COAL CITY PLANNING & ZONING PUBLIC HEARING

VILLAGE OF COAL CITY
PLANNED UNIT DEVELOPMENT Preliminary Presentation Meeting
North Arrow Partners – Hunters Run Property
Thursday, August 22, 2024 @ 4:00 p.m.

DATE: August 29, 2024
TO: Village of Coal City
515 South Broadway Street
Coal City, Illinois 60416
ATTN: Matthew Fritz – Village Administrator
FROM: Timothy Hejny, P.E.
SUBJECT: Hunter's Run P.U.D. Application

Subject: Address of Engineering Concerns, Hunters Run PUD Application

1 TYPICAL BUILDING (TYPE A & B) FLOOR PLAN
SCALE: 1/16" = 1'-0"

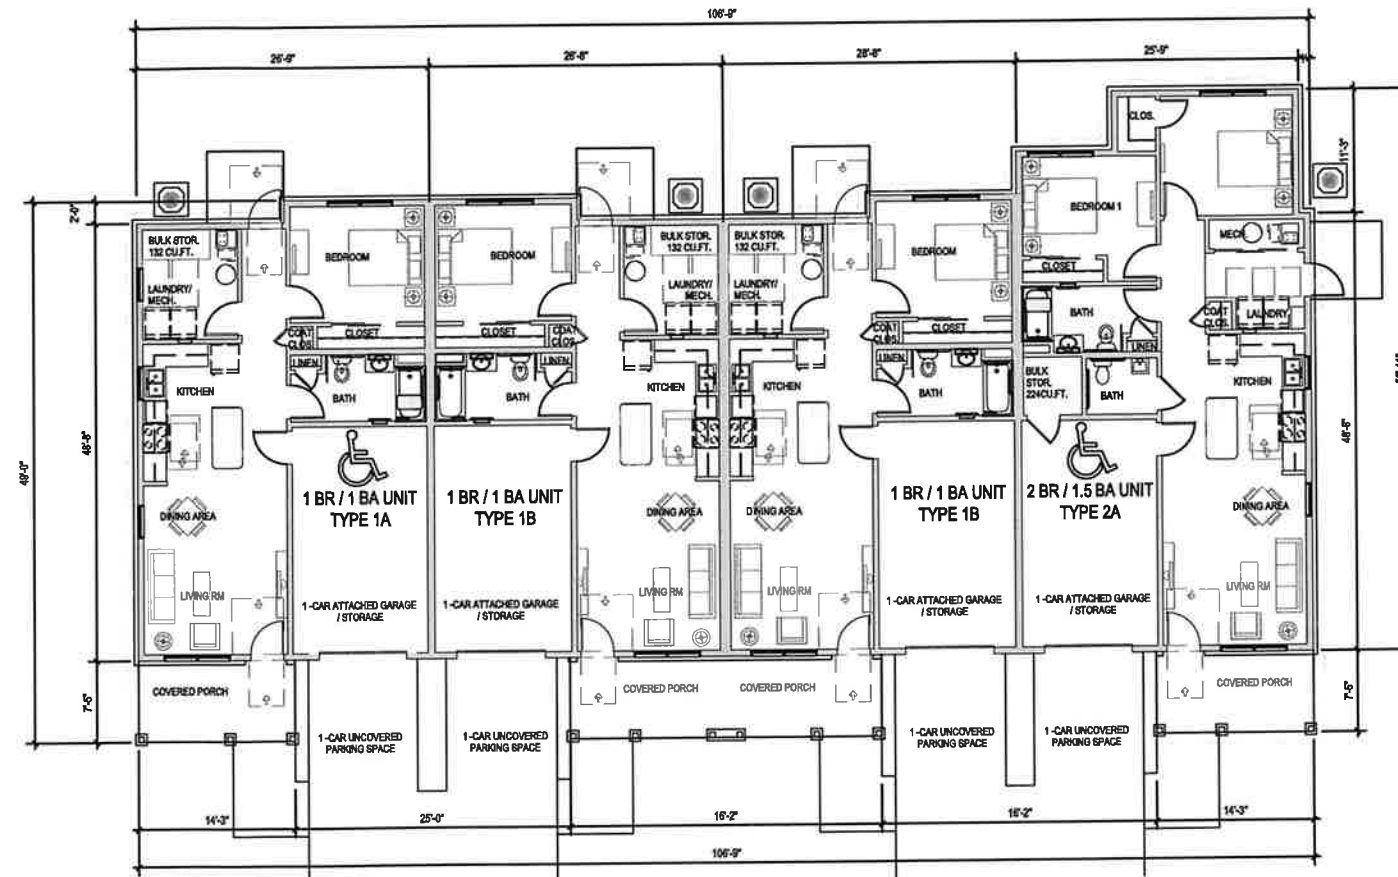
Pam requested to see the rear exit on the diagram and wanted to know what each unit would be losing due to adding the back door. One bedroom unit lost some bulk storage area and the two bedroom they removed a window. Noffsinger also asked about storage in the garage, which shelving units could be added for
